SUBJECT: Arkansas Nuclear One – Response to Request for Additional Information for Proposed Upgraded Emergency Action Levels (EALs) Using NEI 99-01, Revision 4 Methodology

> Arkansas Nuclear One Units 1 and 2 Docket Nos. 50-313 and 50-368 License Nos. DPR-51 and NPF-6

ANO RESPONSES TO NRC REQUESTS FOR ADDITIONAL INFORMATION REGARDING ADOPTION OF NEI 99-01, REVISION 4 FOR ARKANSAS NUCLEAR ONE, UNITS 1 AND 2

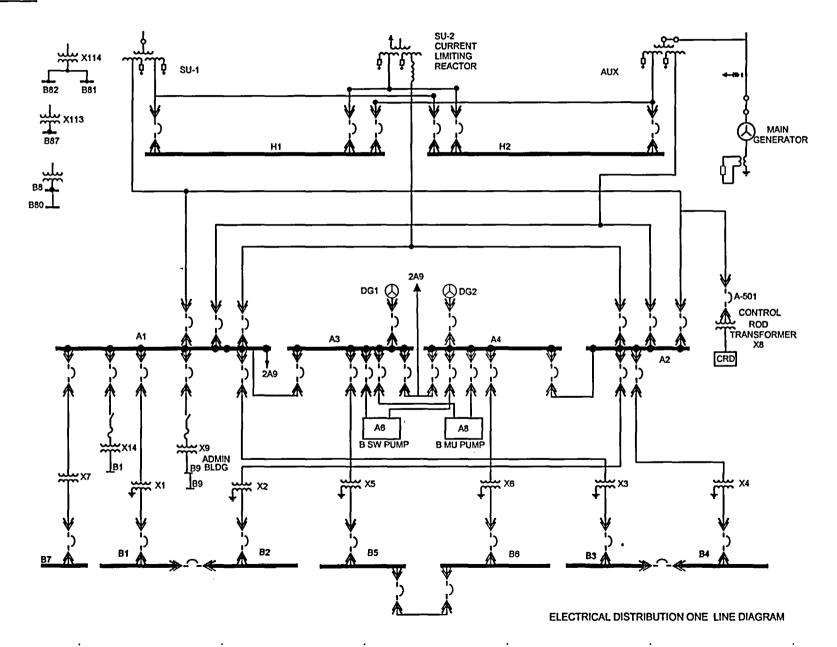
4. Provide a simplified drawing or schematic illustrating unit auxiliary and start-up transformers and describe inter-relationship regarding conditions needed for a loss of off-site power and the ability of emergency diesel generators to supply only essential busses.

Both units receive offsite power from a common switchyard via stepdown transformers, Startup (SU) #1, 2 and 3. (S/U #1 for Unit 1 and S/U #3 for Unit 2 with S/U #2 available to both units to power safety-related equipment during events or limited nonvital loads in non-emergency situations). S/U #1 and #3 are supplied by an autotransformer, which is normally supplied from the switchyard 500KV distribution system (which has 3 separate 500KV sources). The autotransformer can also be supplied by a separate 161KV distribution system; however, loading restrictions will be placed on S/U #1 and #3 if the autotransformer is supplied by the 161KV distribution system. S/U #2 is powered directly from the 161KV distribution system. To completely lose all offsite power would require the loss of all three 500KV power supplies or a loss of the entire 500KV ring bus in the switchyard AND a loss of the 161KV ring bus. ANO also has an Alternate AC Diesel Generator with a 4,400 kilowatt capacity that can supply one non-vital and two vital busses on each unit. Both units have the ability to backfeed non-vital busses from the emergency diesel generators and have emergency operating procedure guidance to do this.

For Unit 1, the Unit Auxiliary transformer is available to supply power should it be necessary. This is not the case for Unit 2. Unit 2's Unit Auxiliary transformer is not normally connected to the electrical distribution system, but is available during some outage evolutions. In order for the Unit 2 Unit Auxiliary transformer to be used, hard connections from the main generator to the electrical distribution system must be manually disconnected.
